# **PLANNING & ZONING AGENDA ITEM #6**

***SUBJECT:*** Approval of a Final Plat for Boulder Pointe

**RE:** Boulder Pointe Townhomes – Final Plat & Site Plan

## COMMENT RESPONSE LETTER

**BOULDER POINTE**  
**FINAL PLAT**

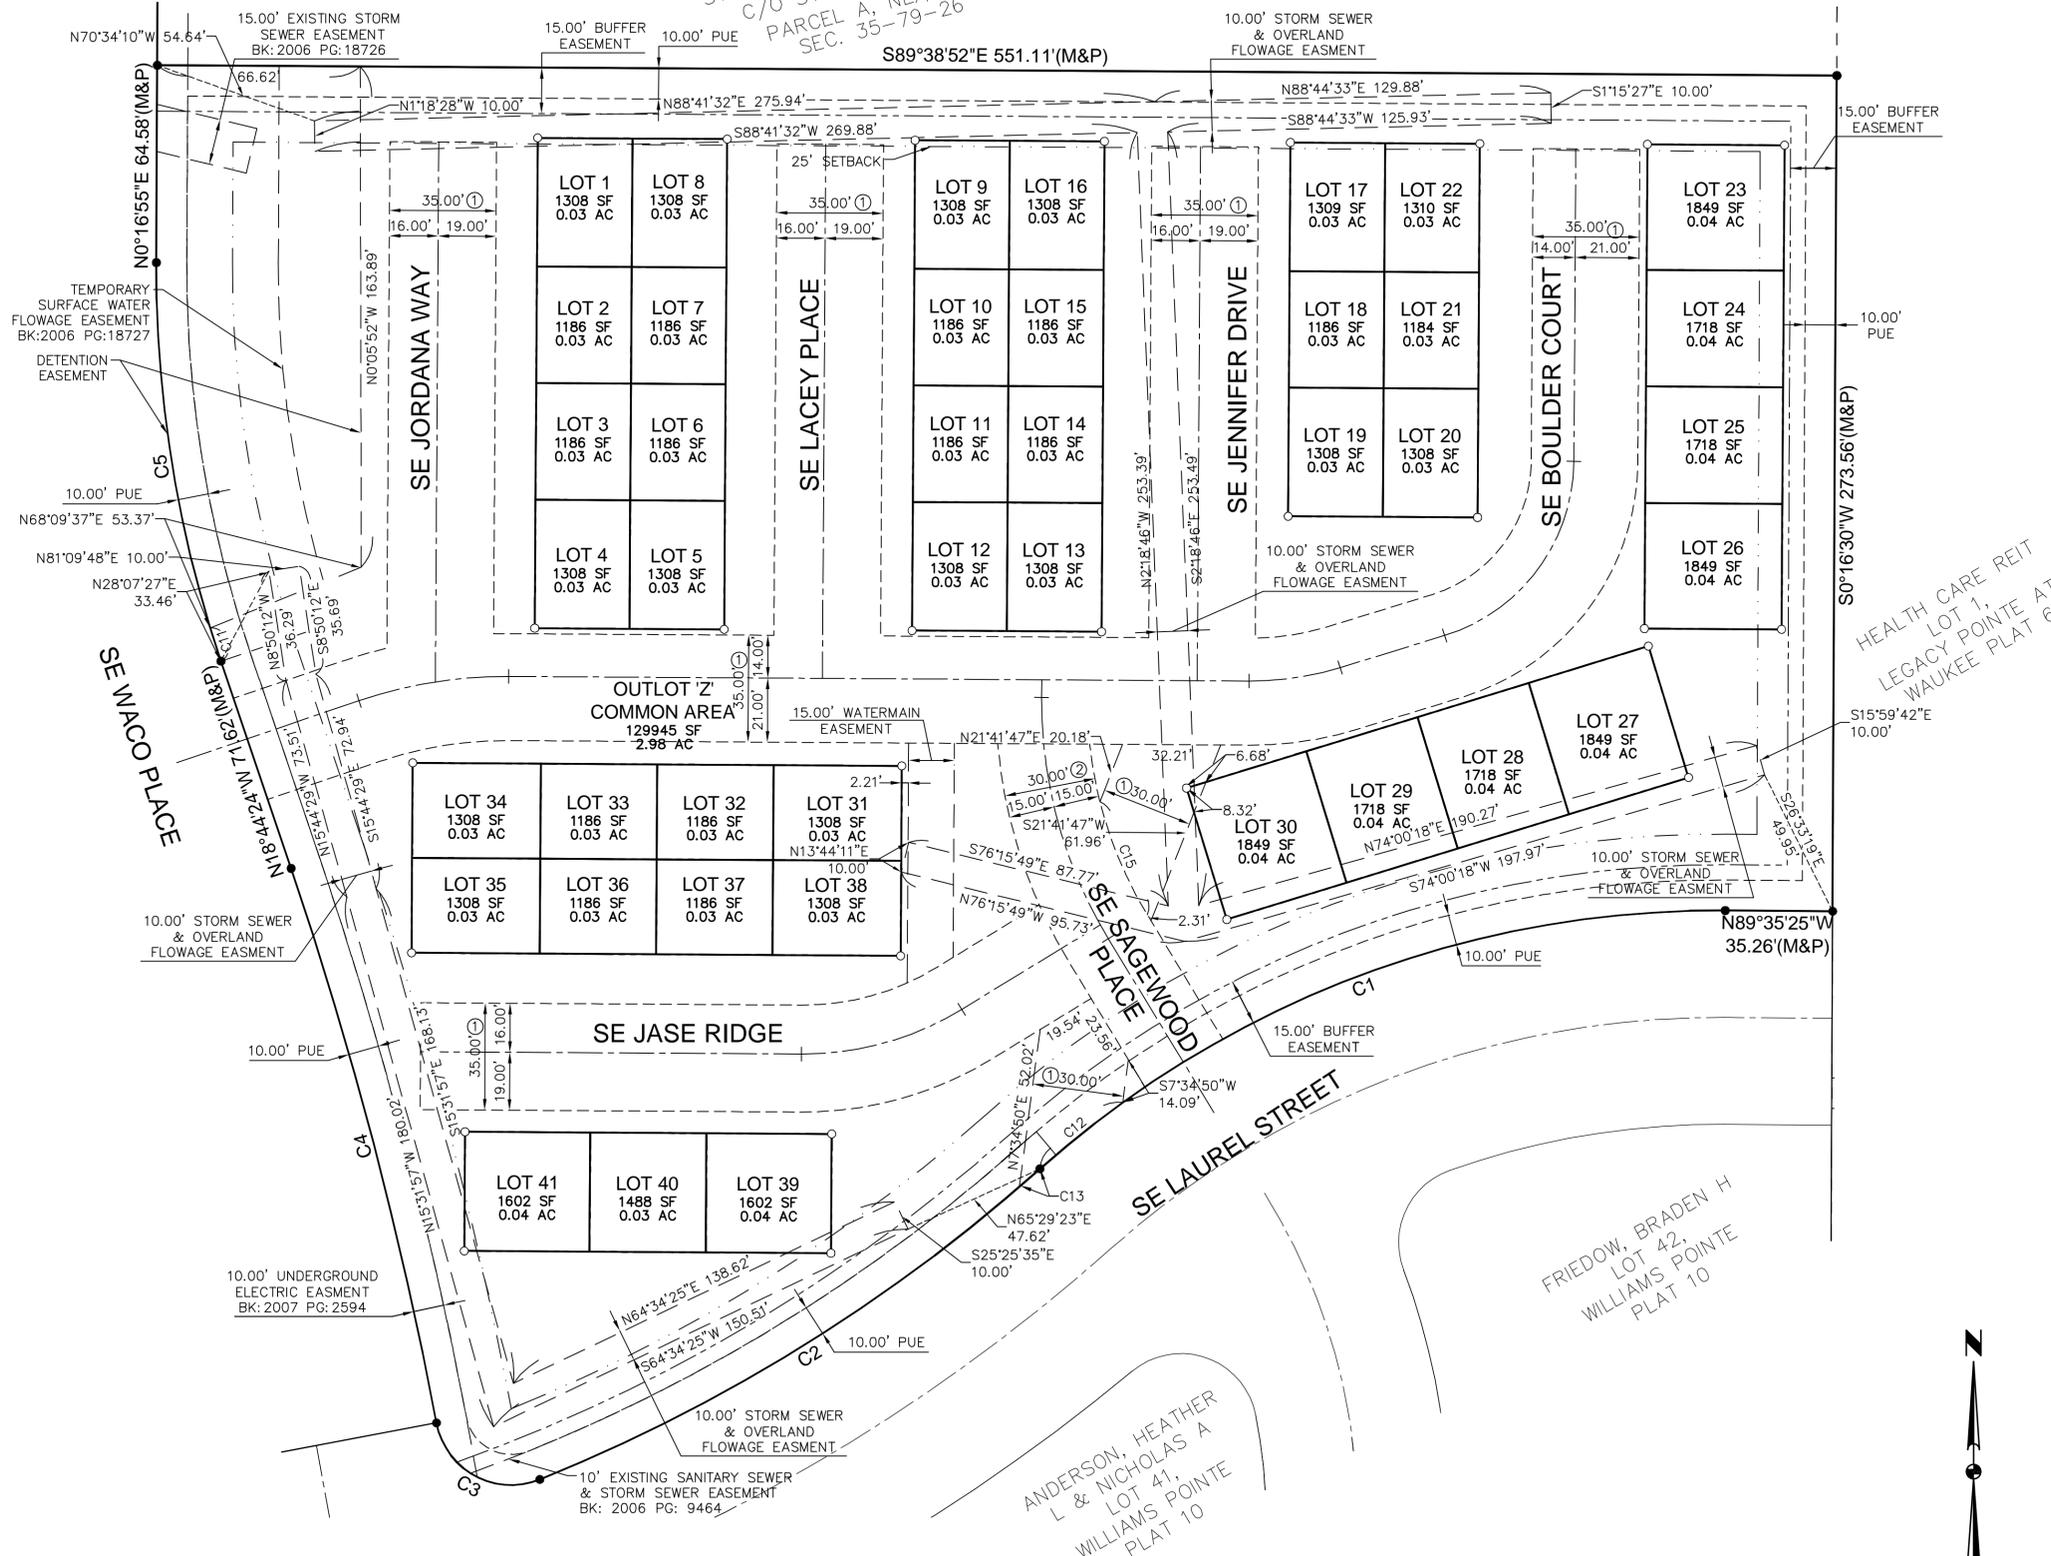
75. As noted in the site plan comments, street names should be updated with the 'SE' prefix and an alternate name for Indi Ridge should be provided and indicated on the plat.

76. The adjacent lot ownership should be indicated on the plat.

77. Verify the proposed storm sewer and overland flowage easement though Lots 27 – 30 do not affect the ability to place a stoop in them.

78. A note should be added to the plat indicating the overall site address of Oulot Z of 255 SE Waco Place.

79. A note should be added to the plat indicating the public sidewalks adjacent to SE Laurel Street and SE Waco Place to be installed as a part of the site improvements.

- **Street names have been updated.**

- **The lot owners have been added.**

- **The stoop does not interfere with the overland flowage easement.**

- **This note has been added.**

- **This note has been added.**
